Revised Technical Review of Western Power's Proposed Revisions of its Fourth Access Arrangement 2017/18-2021/22

Economic Regulation Authority

Final Report

19 September 2018

Figure 1 Risk priority for substation fences by assessed condition

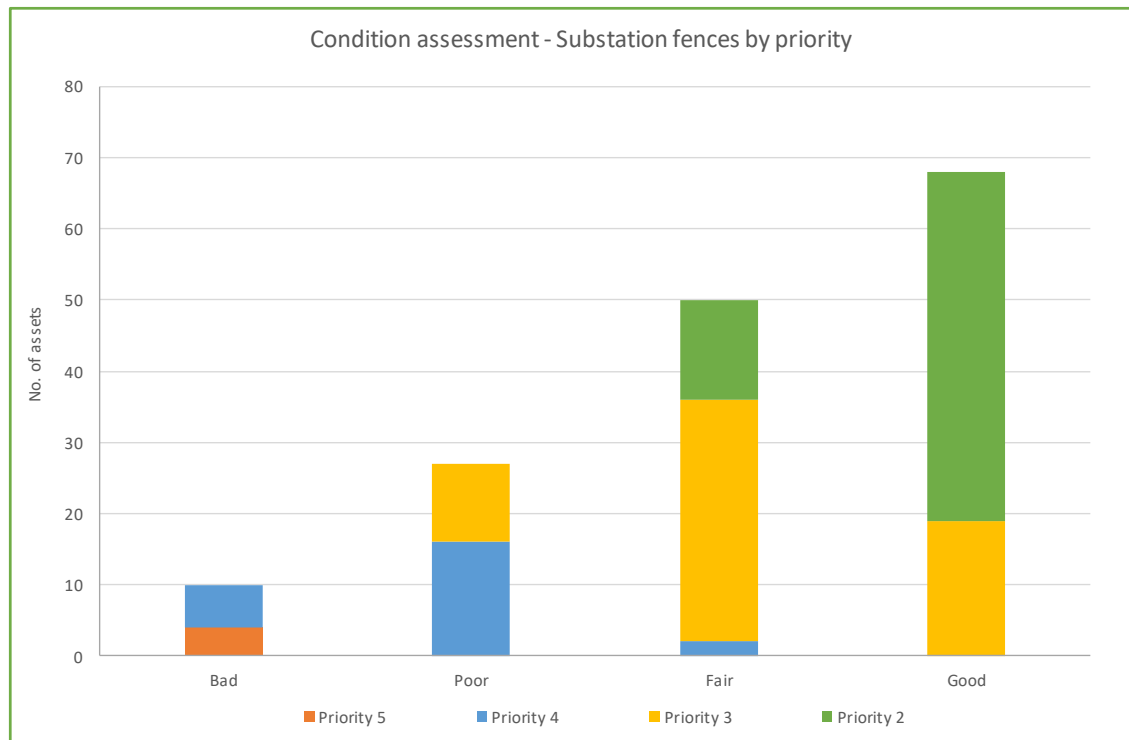
We agree with the proposed replacement program for 2017/18 and 2018/19, as these focus on the fences with the highest risk scores. However, we note Western Power has suggested in the substation security asset strategy and in response to the ERA that investment is informed by risk assessment outcomes including consideration of asset condition inspections. Therefore, we do not accept that Priority 3 fences are scheduled for investment in the latter years of AA4 whilst Priority 4 fences, typically in Poor condition, are not planned to be replaced.

Figure 3 Substation roof population age profile

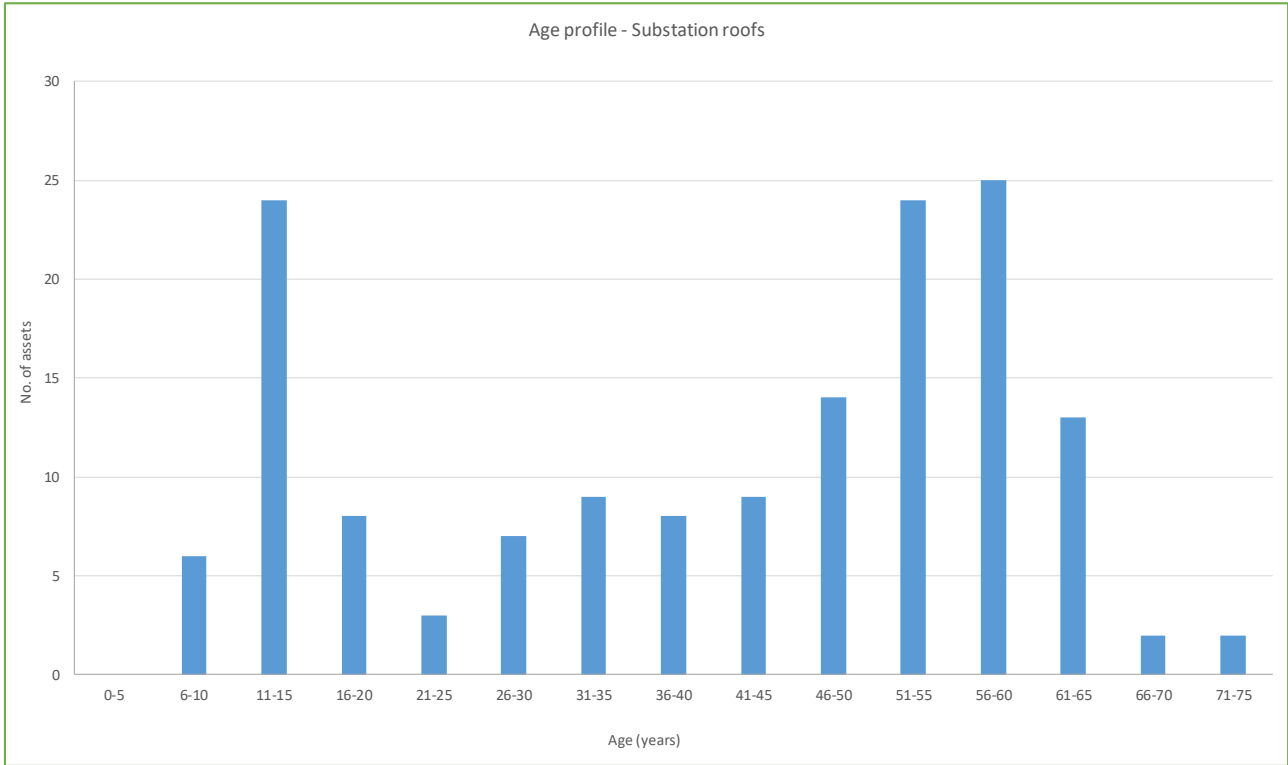
Approximately 43% of the substation building roofs are over-age (in-service age > 50 years).

Figure 4 Substation roof assessments by priority

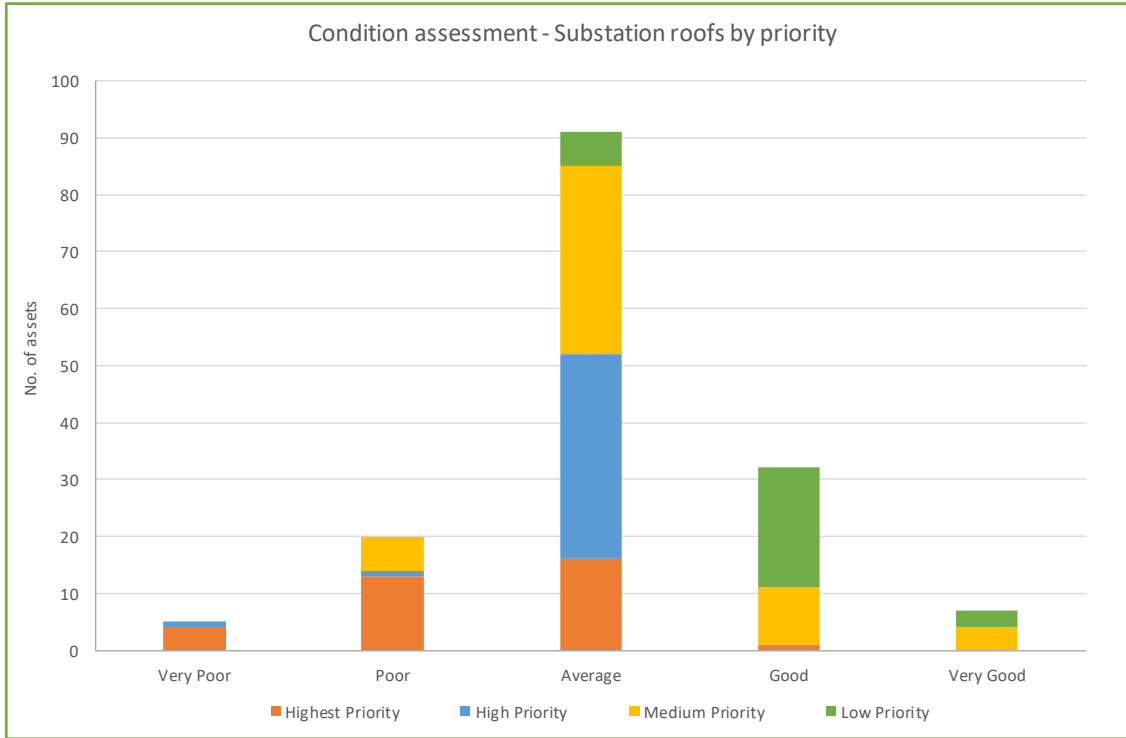
Figure 4 suggests that the roofs that have been identified as being in Very Poor condition (5 in total) are classified as 4 Highest Priority and 1 High Priority, and for those in Poor condition, there are 13 that are considered Highest Priority, 1 High Priority and a further 6 that are only Medium Priority.

It also shows that there are 16 considered Highest Priority and 36 High Priority roofs that are in Average condition. The replacement program proposed by Western Power calls for 4 roofs to be replaced annually for the next 10 years.

We consider the analysis of the roofs based on the Western Power priority classification vs condition (refer Figure 4) and classification vs consequence (refer Figure 5) suggests that the progress proposed by Western Power for AA4 of 4 roofs per year is the minimum necessary to address the current and future risk profiles. The current population has 23 roofs that are classified Highest or High Priority for roofs with catastrophic consequences of failure, and 5 with Highest Priority for roofs with a major failure consequence. Western Power has identified 6 roofs with Highest Priority that are designated as requiring immediate replacement, with which we agree as these are part of the 23 roofs we have identified as the most likely requiring prompt attention.
